NOTICE OF PUBLIC MEETING

Pursuant to Section 19.84, Wis. Stats., notice is hereby given to the public that the **Plan Commission** of the City of De Pere will have a **special meeting on March 13, 2013 at 6:00 p.m.** in the City Hall Council Chambers, Second Floor, City Hall, 335 South Broadway, De Pere, WI 54115.

1. Roll Call.
2. Review the proposed Walgreens project located at 135 South Broadway. *
 - a. Review the Rezoning Application from Central Business (B-1) to Central Business with a Planned Development Overlay (B-1 PDD).*
 - b. Review the General Development Plan for the proposed Walgreens.
3. Adjournment.

Item #5b: Review the General Development Plan for the proposed Walgreens.

EXHIBIT 2 PRELIMINARY SITE PLAN

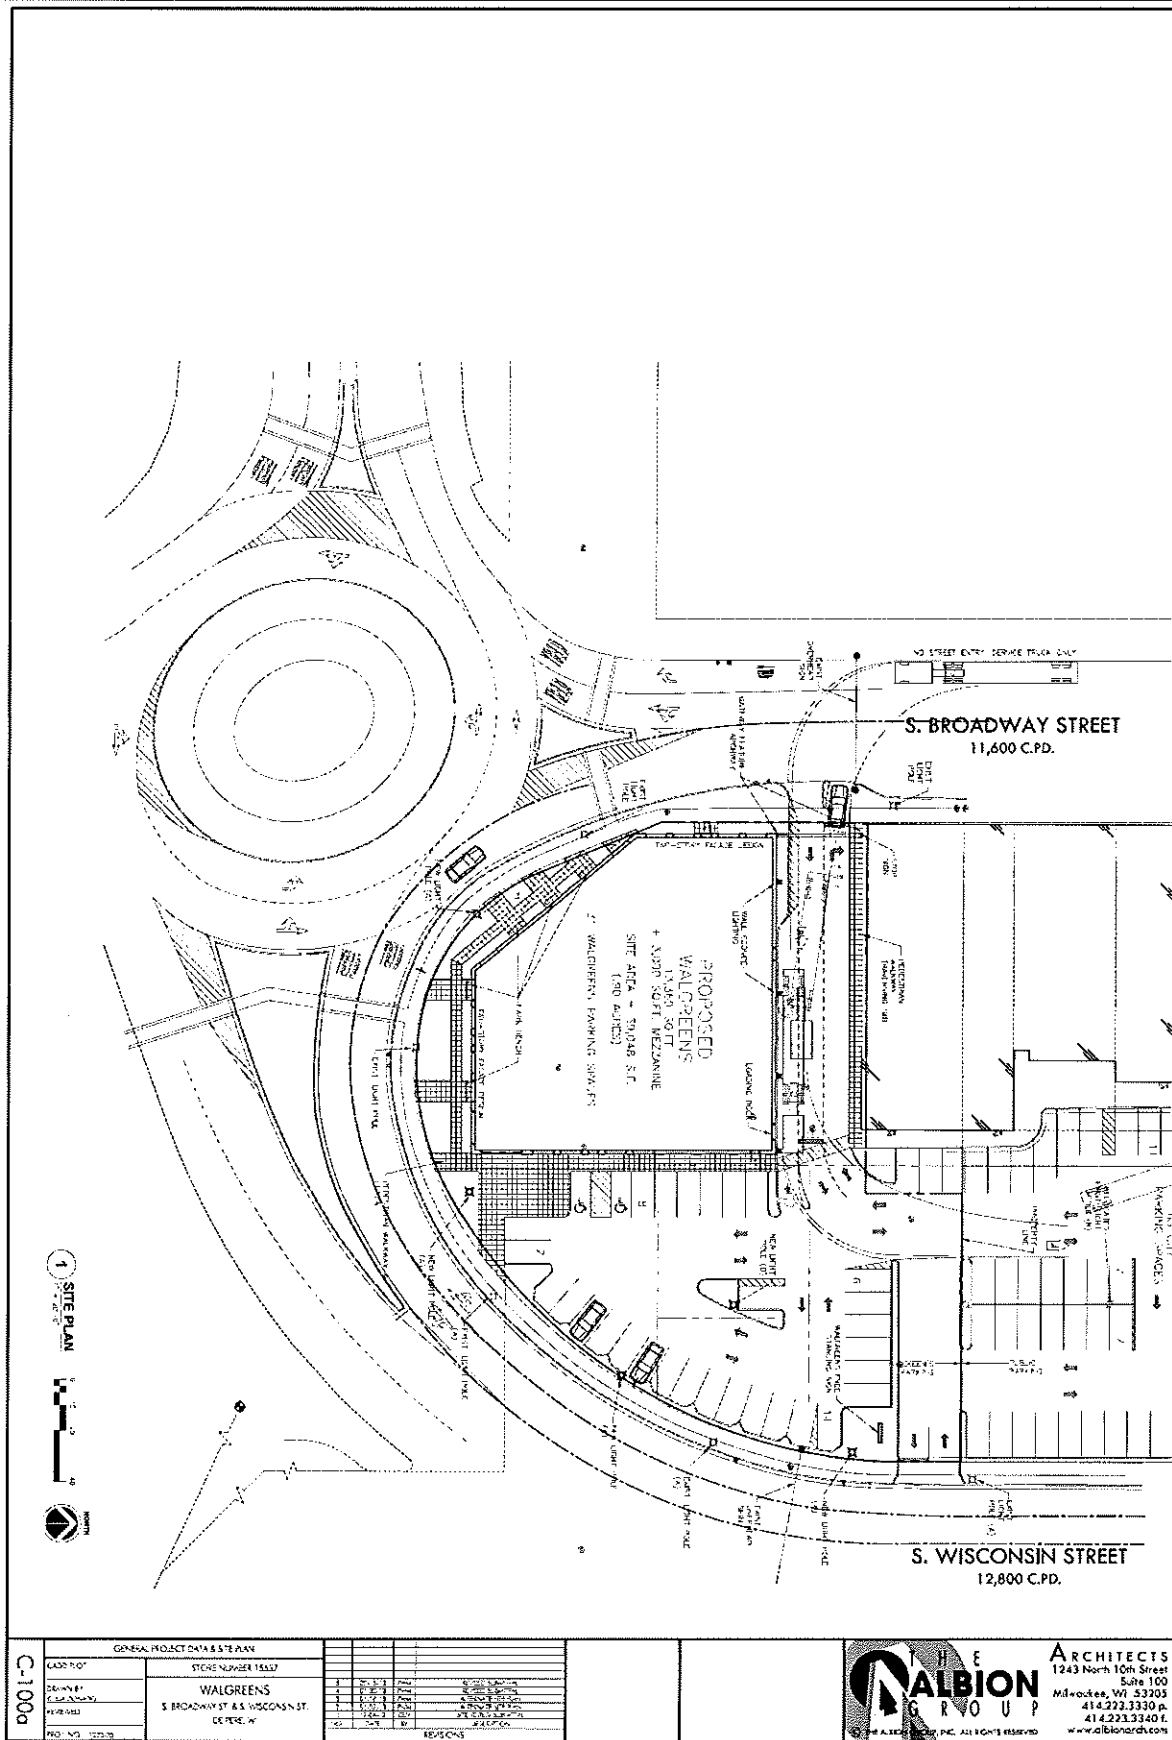
c. Eliminate / review driveway onto Broadway and drive through design.

The proposed left-in/right-in/right-out driveway is expected to operate safely and efficiently along Broadway based on the results of this analysis and verifications of ISD and SSD.

To further enhance safety and operations along Broadway, consideration should be given to revising the pavement markings on Broadway between the roundabout and the proposed driveway (see Exhibit 9). More specifically, remove the cross-hatching that exists over the west exit lane and replace it with cross-hatching over the east exit lane. This change is expected to further improve sight distance to pedestrians crossing the roundabout, further improve sight distance to/from the proposed driveway, and improve the safety of parallel parking maneuvers along Broadway.

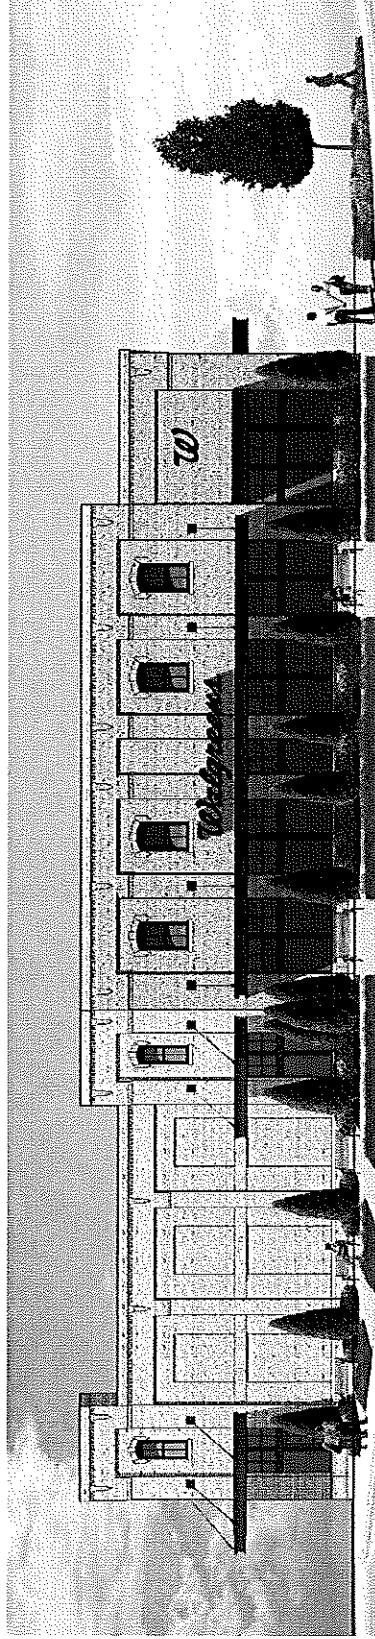
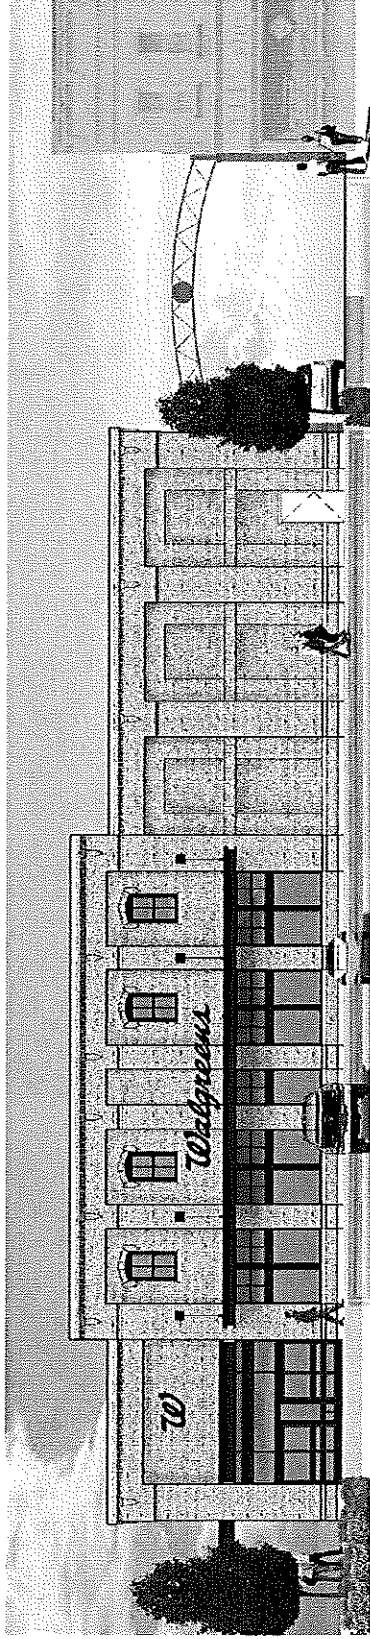
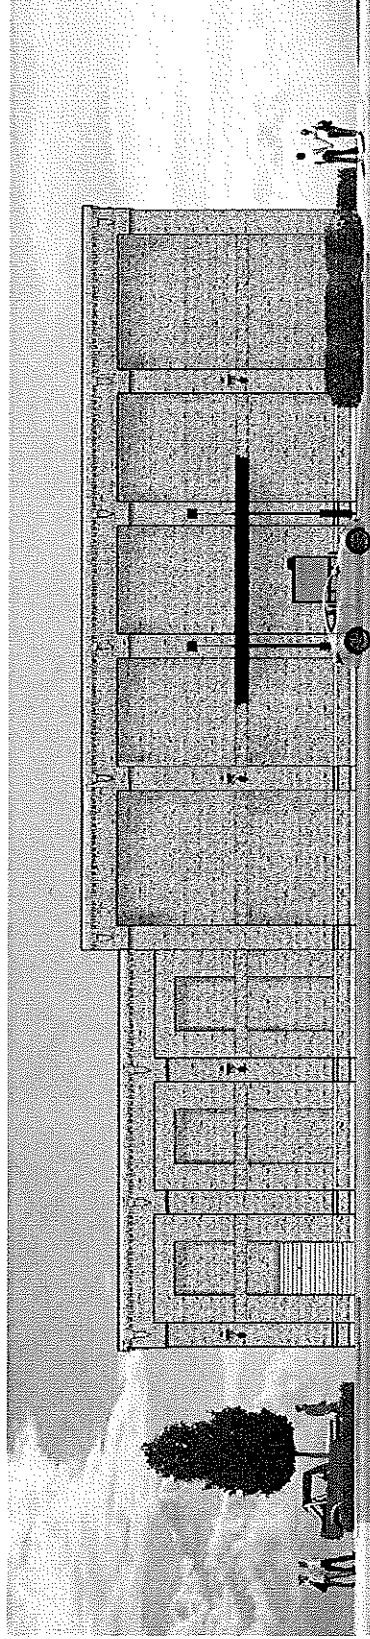
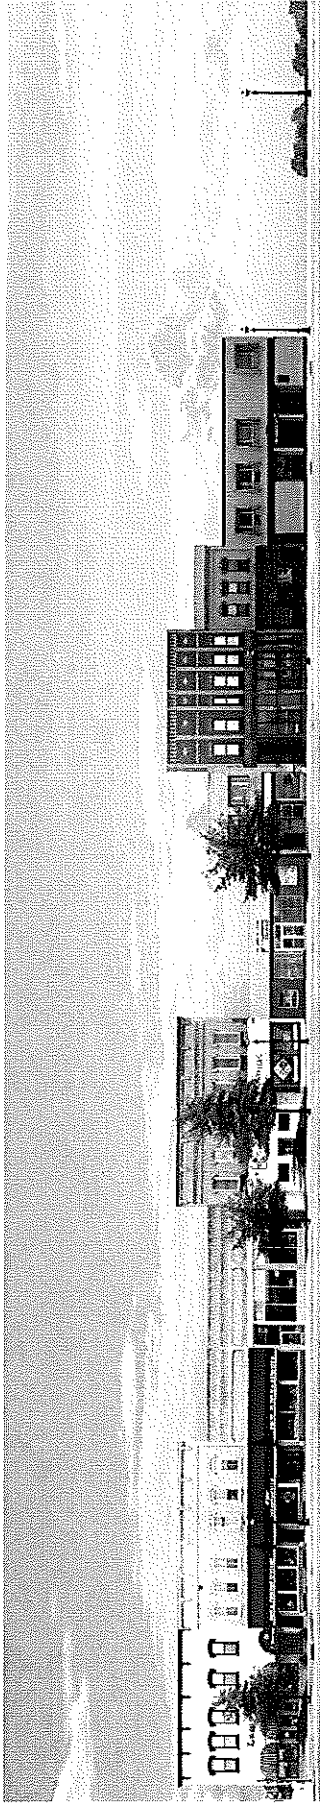
f. 'Tweak' building design to better fit into block

After several meetings with city staff, the Historic Preservation Commission, Main Street Design Committee and nearby business owners, we have come up with a set of elevations

that virtually everyone has had input with. Our architect, The Albion Group, is actually located in an 1880 Pabst Brewery building in Milwaukee. He took many design features and elements from his building, and those found through this part of Downtown De Pere, and incorporated them into our building. Our store is the result of input from many varied groups and has the appearance of a historical building retrofitted for a Walgreens (SEE PLAN SUBMITTAL).
